MIL-I-48634 (AR)
AMENDMENT 2
20 February 1989
SUPERSEDING
AMENDMENT 1
23 July 1988

MILITARY SPECIFICATION

INTEGRATED CIRCUIT, DIGITAL, CMOS LOGIC ARRAY MONOLITHIC SILICON

FIGURE 3. LEAKAGE CURRENT TEST.

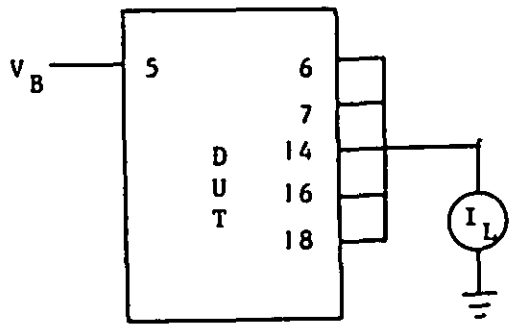
Add the following figure:
